TECH EXCHANGE

SUBJECT: 2018~2021 CZD300 (XMAX) — Service Manual Corrections – Lock Cable Routing Illustrations and Hardware Description Corrections

Page 2-23

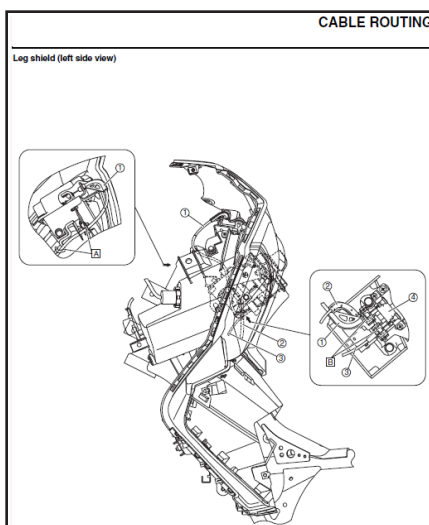
The new illustration has been added to show the proper routing of the front compartment lock cable and the fuel tank cap lid lock cable.
